AGENDA
Planning Commission Regular Meeting
Tuesday, July 25, 2023
6:30 PM
City Council Chambers, City Hall

AGENDA ITEM:	Request by KJ Walk for an amendment to the Rosewood Commons PUD and conditional use permits for an outdoor seating area and a drive-through facility.	**AGENDA SECTION:**	PUBLIC HEARINGS
PREPARED BY:	Anthony Nemcek , Senior Planner	**AGENDA NO.**	6.a.
ATTACHMENTS:	Site Location, Site Plan, Grading Plan, Landscape Plan, Elevations, Trash Enclosure, Perspective 1, Perspective 2	**APPROVED BY:**	AK

ROSEWOOD COMMONS SECOND ADDITION
ROSEMOUNT, MN

LANDSCAPE PLAN

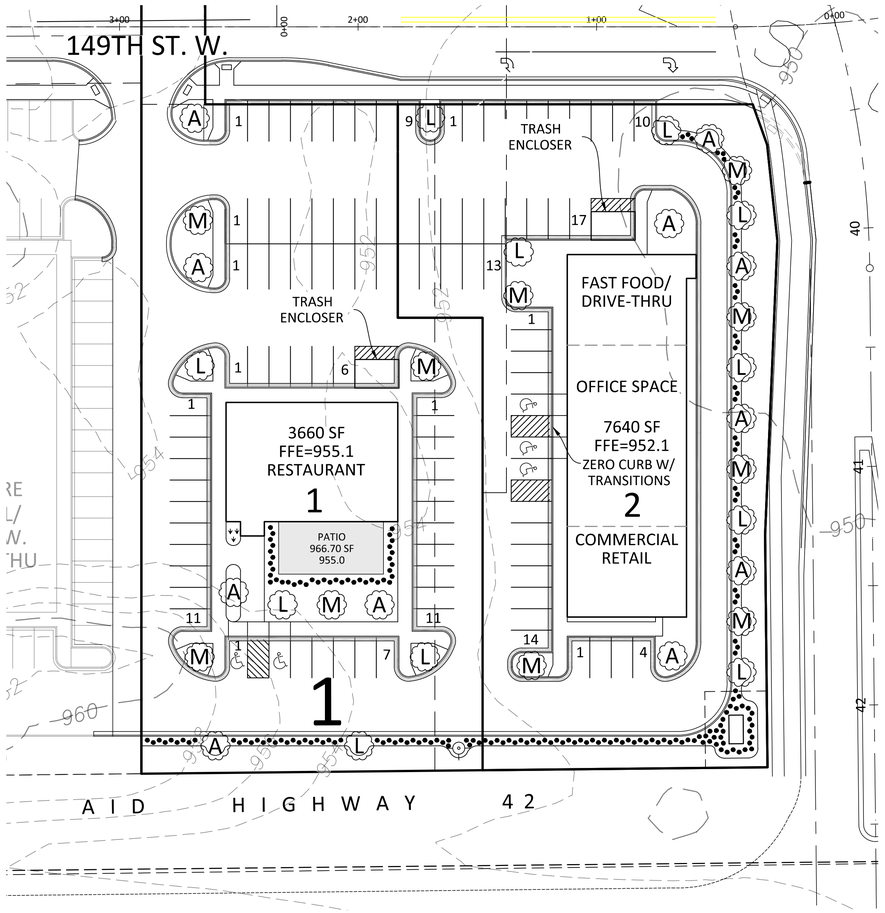
The applicant has provided a landscape plan with their submittal that generally meets the requirements of the City's zoning ordinance based on the size of the subject property. The City Code requires one tree per 3,000 square feet of site area, which in this case results in a requirement of 25 trees. There is an additional requirement related to the landscaping of the parking areas. The code requires landscaping around the parking lot equal to 10% of the total parking area, which in turn must contain one tree per 250 square feet of parking lot landscaping. This tree requirement is in addition to the number of trees required based on the size of the site. Therefore, the total number of trees required on site is 43. Staff worked with the applicant to update their plan to provide more parking lot landscaping, which now meets the code requirement, and to identify where more trees might be placed to get closer to the total tree requirement of 43 trees. A shortfall still exists, and staff is recommending a deviation that does not require the parking lot landscaping to be calculated in addition to that required based on site area.

Staff is also including a recommended condition that the applicant update the final landscape plan to replace the trees identified as ash trees with another species due to the impact of the emerald ash borer on existing tree populations in the region.

f. The landscape plan shall be updated to replace ash trees with another species.
    g. The applicant shall apply for a sign permit for any site signage.

PAVING PLAN

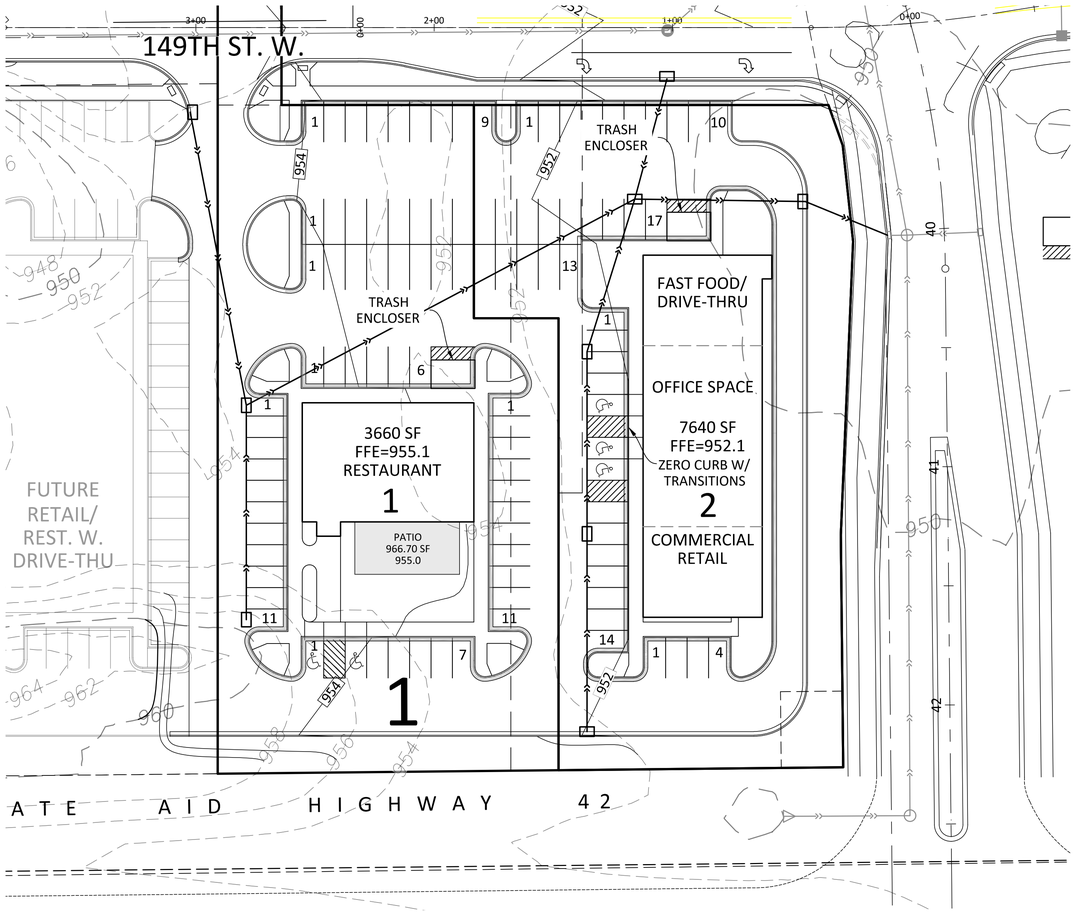
The site plan provided by the applicant shows a total of 105 parking spaces on the site. The applicant estimated parking requirements based on the anticipated number of seats in the restaurant areas and the square footage of the retail/office portion of the multi-tenant building. The code requires 6 stalls per 1,000 square feet of retail or 5 stalls per 1,000 square feet for shopping centers. Office uses also require 1 stall per 200 square feet or 5 per 1,000 square feet. Staff agrees with the calculations provided by the applicant as shown in the table on the attached site plan, which shows the site falling just shy of the code requirement of 105 stalls by three stalls. The applicant's initial submittal provided enough parking stalls to meet the requirement. Following the direction of staff to relocate a trash enclosure and add an additional enclosure, as well as to provide an additional parking lot island to accommodate more landscaping, the total number of parking stalls was reduced by three. Staff supports the level of parking shown and is recommending approval of a reduction in the number of stalls required on the site by three. Staff is also recommending a condition of approval that limits restaurant seating to that shown on the table to ensure sufficient parking is provided once the restaurants are built. The seating will be reviewed for compliance with that condition during the building permit process.

Total Provided	102 stalls

b. A deviation from Section 11-6-1: Off Street Parking to reduce the minimum number of parking stalls from 105 to 102.
    c. a deviation from Section 11-6-3: Landscaping Requirements to remove the requirement that the number of trees required as part of parking lot landscaping be in addition to the number of trees required based on site area.

ROSEWOOD COMMONS SECOND ADDITION - TRASH ENCLOSURE

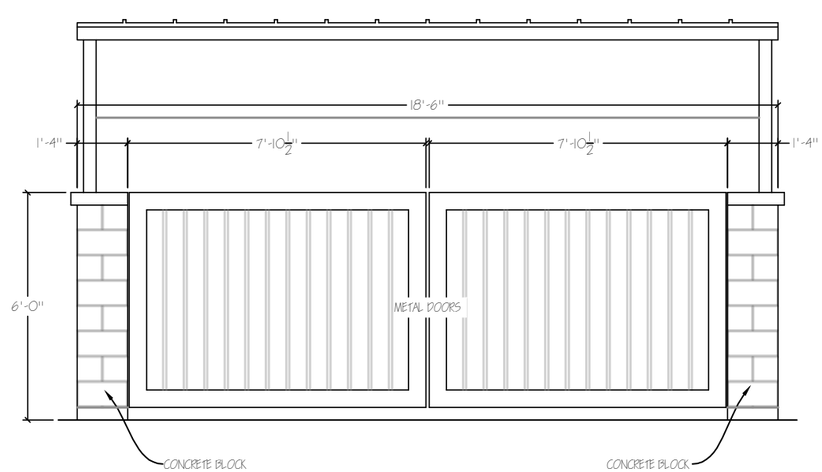
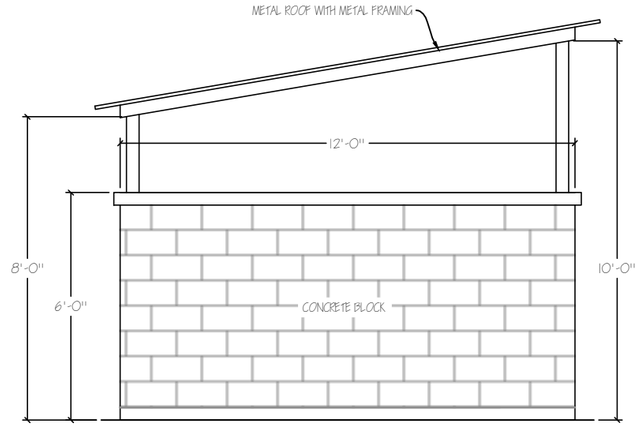
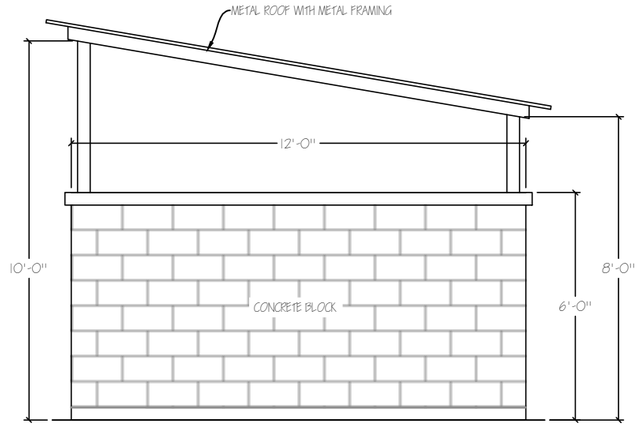
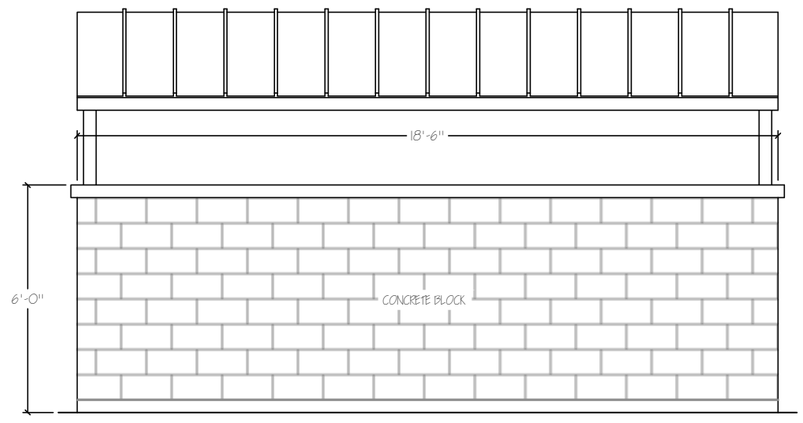
The applicant's plans show two trash enclosures constructed of durable materials that generally meet the requirements of the code. Staff worked with the applicant to adjust the site plan to ensure there are not conflicts with traffic movements in the site, particularly related to the drive-through facility. The elevations indicate that applicant would construct the enclosures using concrete block. The code requires trash enclosures for new construction to complement the principal structures on the site. Therefore, staff is recommending a condition of approval to update the design to feature exterior materials similar to that of the principal structures.

d. The trash enclosure plans shall be updated to feature exterior materials that match the principal structures.
    e. The total number of restaurant seats shall not exceed 218 between the two buildings.
